## FOUNDATION INVESTIGATION REPORT

Proposed Chester Creek Crossing  
Hwy. 65 - New Liskeard Westerly  
District No. 14 (New Liskeard)

W.J. 69-P-39 -- W.P. 39-67-02

Chester Creek Bridge (South Wabi River)  
W.P. 39-67-02, Site No. 47-49  
Highway 65, District No. 14

CHESTER CREEK

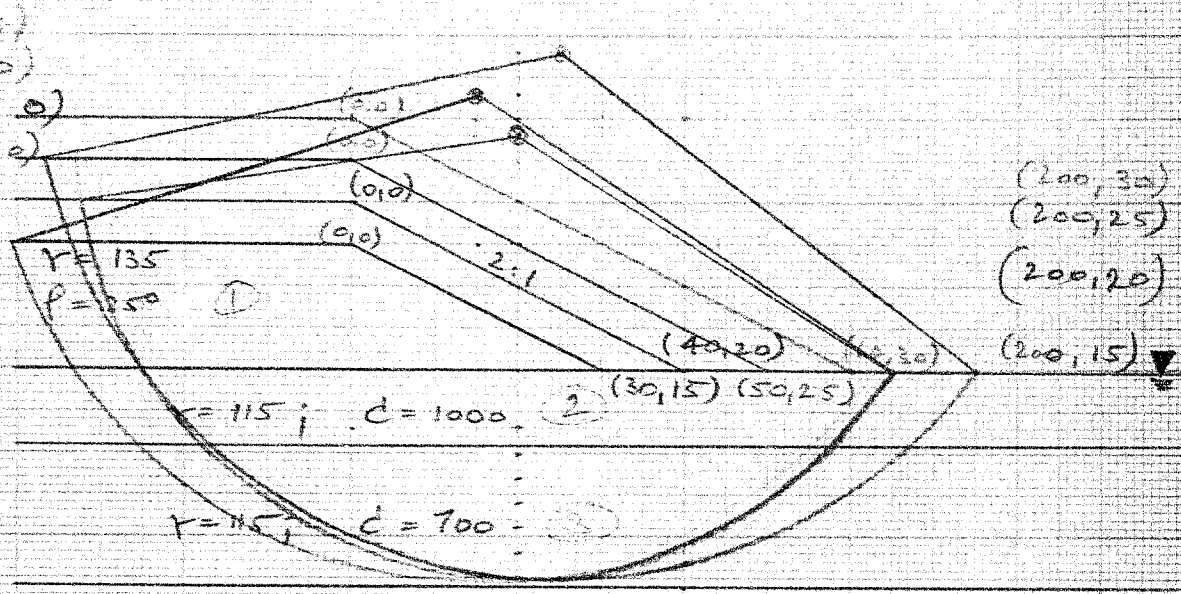
Beams to be provided = 30 ft.

Where the fill height is more than 23 ft., stabilizing berms will be required. For 30-ft. high fills, 1/2 height berms of length 30 ft. should be constructed. Slopes should be 3 horizontal to 1 vertical.

FIGURE (3)

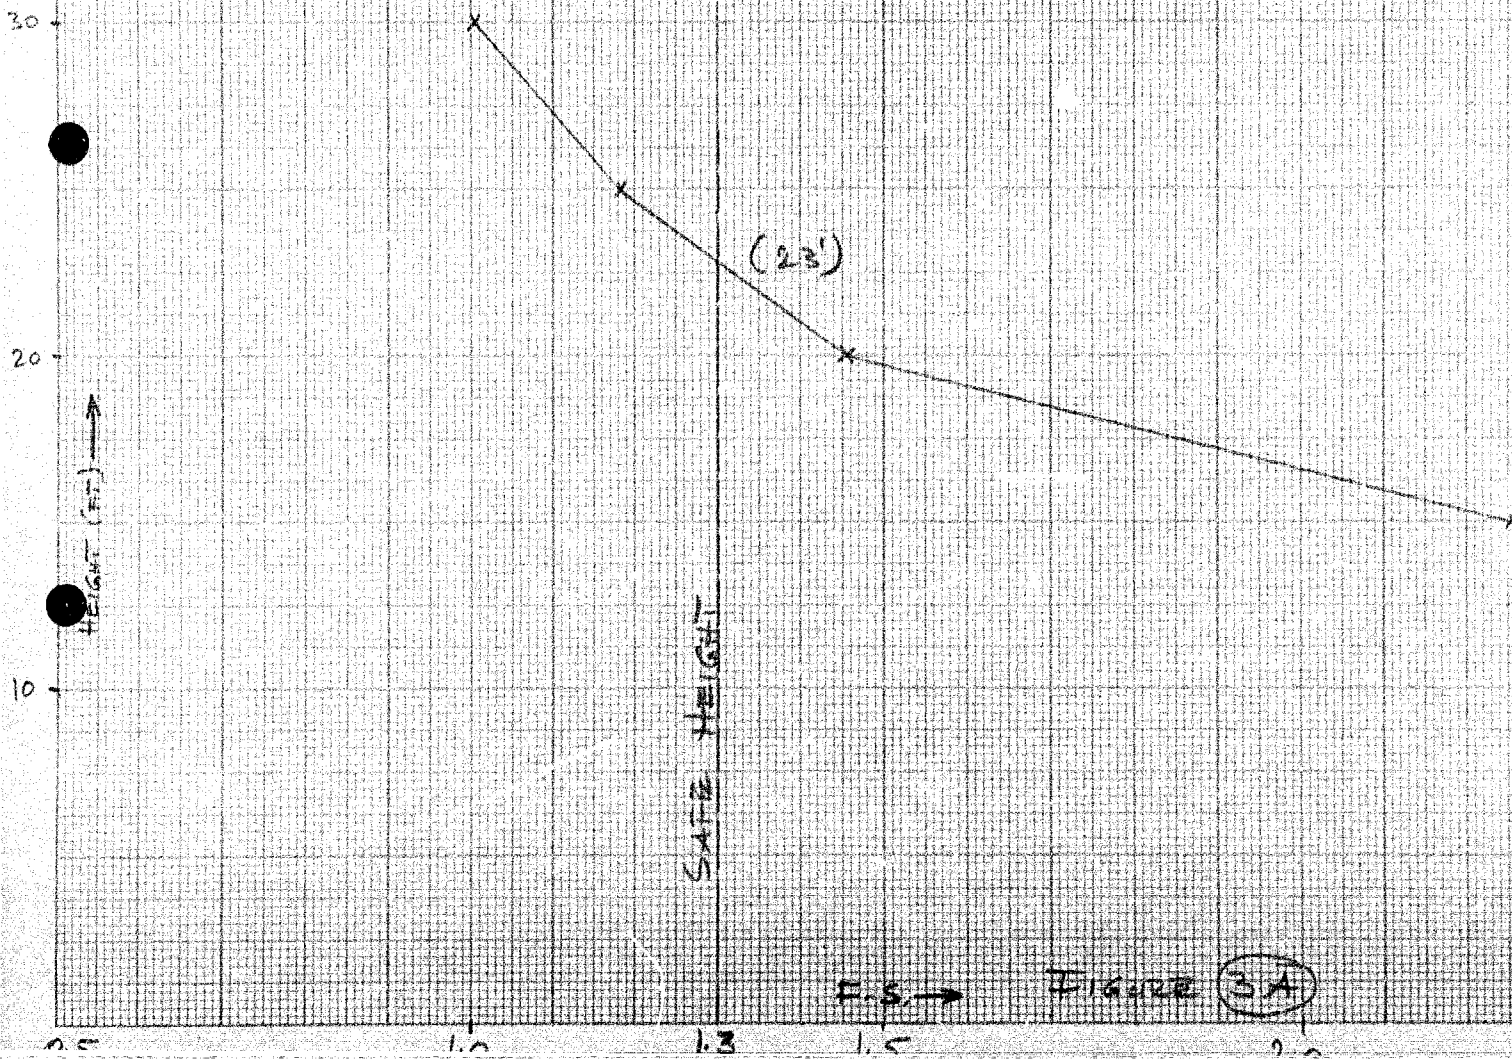
SAFE MAXIMUM HEIGHT  
FIGURE ③ AND FIGURE ③A

LINE "A", "B", "E" AND "D"

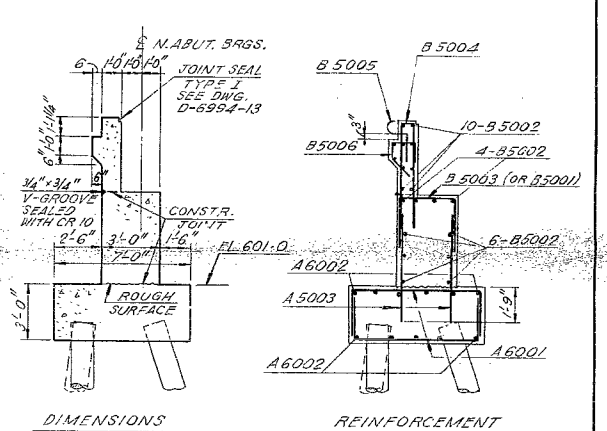
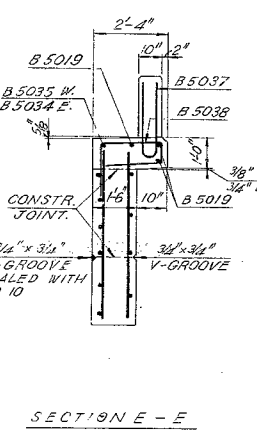
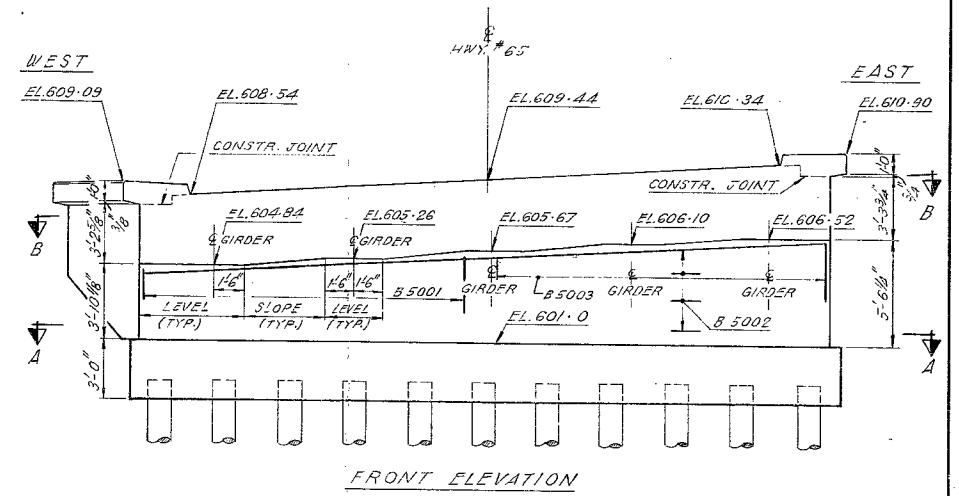
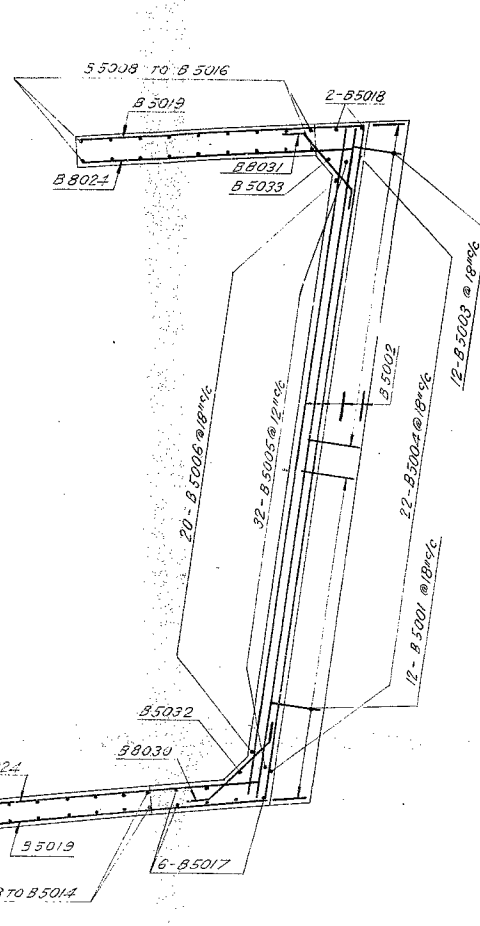
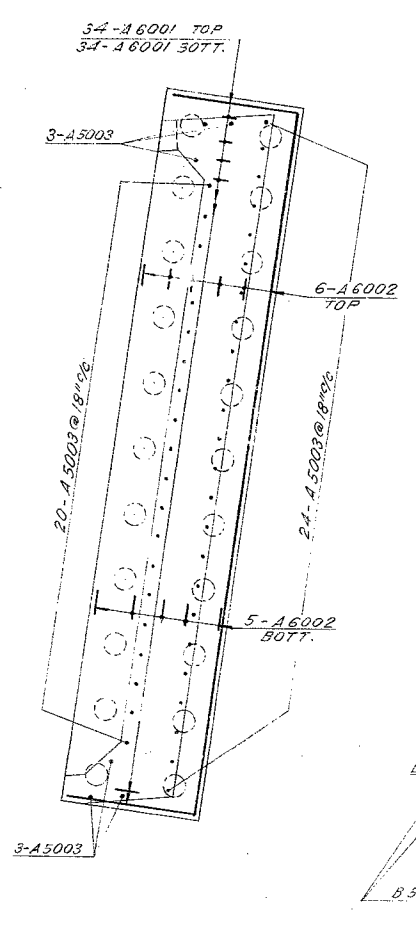
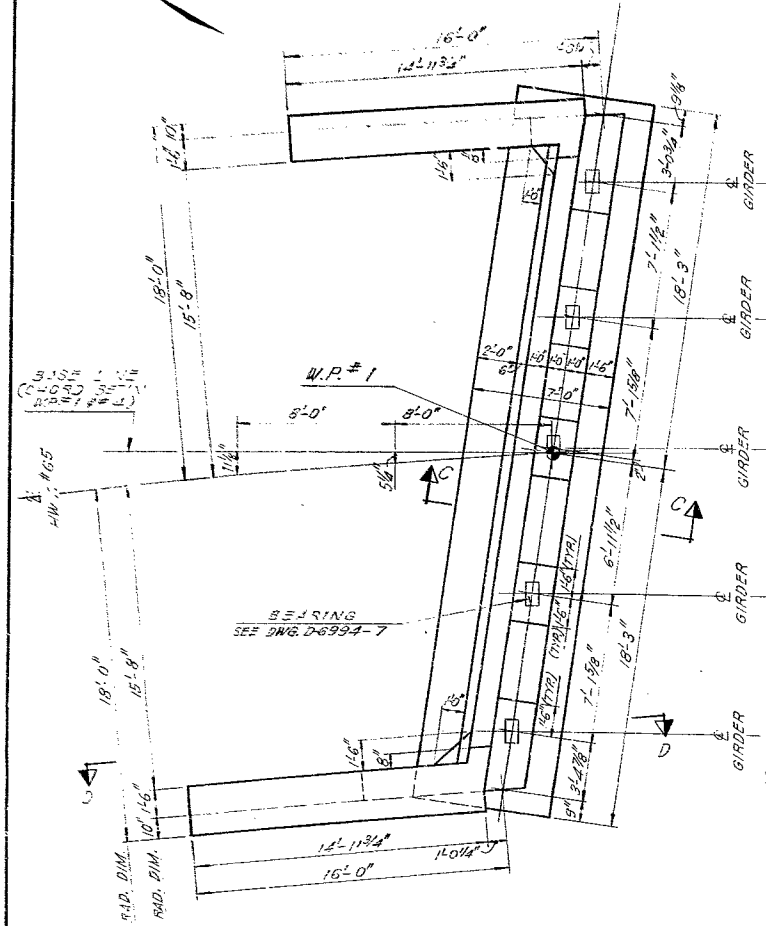
COMMENTS: (1) Note for pile driving should read: "#14 treated timber  
piles driven to tip  
elevations as shown:

(Mention of design load  
might imply use of Hiley  
Formula, which is not valid  
for this site.)

N. Abutment	--	El. 551
N. Pier	--	El. 540
S. Pier	--	El. 542
S. Abutment	--	El. 552"

(2) Suggested construction note: "Excavations for pier  
"Excavations for pier foundations may  
precipitate failures of the existing  
varved clay slopes unless adequate  
precautions are taken"
